REMARKS

Serial No.: 10/606,218
Art Unit: 2682

Attorney's Docket No.: GRI-101-CON (520763-0000001)
Page 18

Amendments to the Drawings:

Figure 3

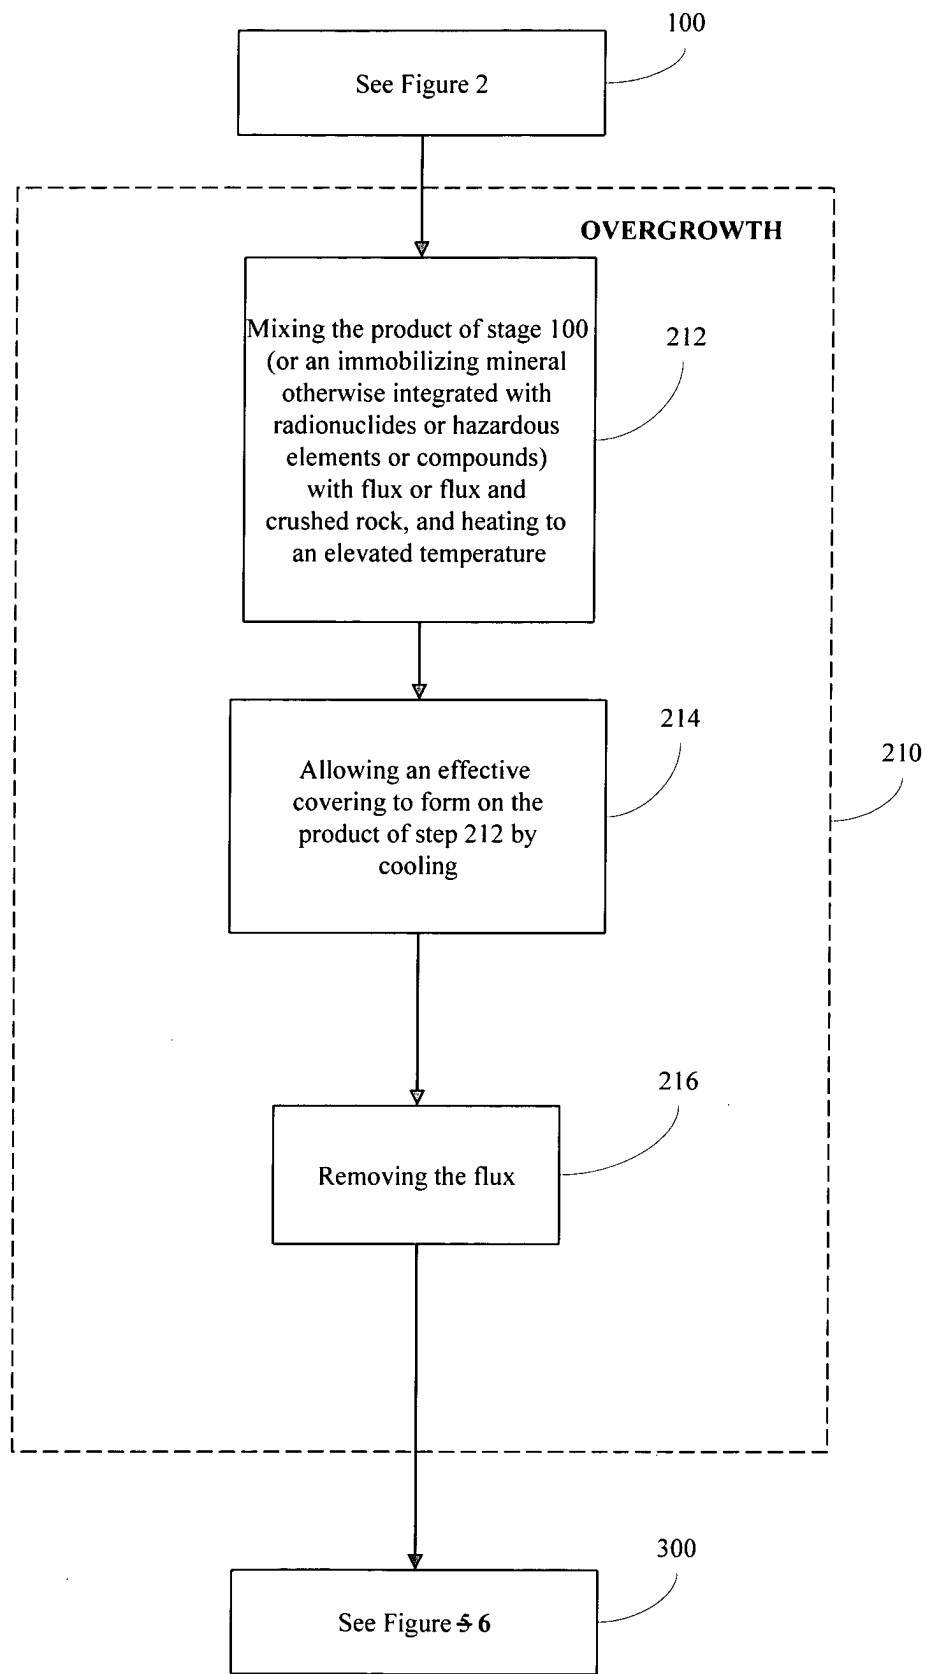
Figures 3, 4, and 10 have also been corrected, per the Examiner's suggestion, to correct typographical errors. Element 300 in Figures 3 and 4 was corrected to refer to Figure 6 (instead of Figure 5). Support for this amendment can be found in the original drawings, for example in Figure 6 which contains an element 300 and refers back to Figures 3 and 4. Figure 10 has also been corrected, in that the words "[transformed mineral and]" have been deleted from element 1014. Support for this amendment can be found in the specification, for example at paragraph [0104]. No new matter enters by these amendments.

The attached sheets of drawings include changes to Figs. 3, 4, and 10, and clean copies of Figs. 1, 2, 5-9, and 11. Fig. 11 is shown in color, and a petition for acceptance of this color drawing has been submitted concurrently herewith. These attached drawing sheets, which include Figs. 1-11, replace the original sheets including Figs. 1-11. Annotated sheets showing the changes made to Figs. 3, 4, and 10 are also attached.
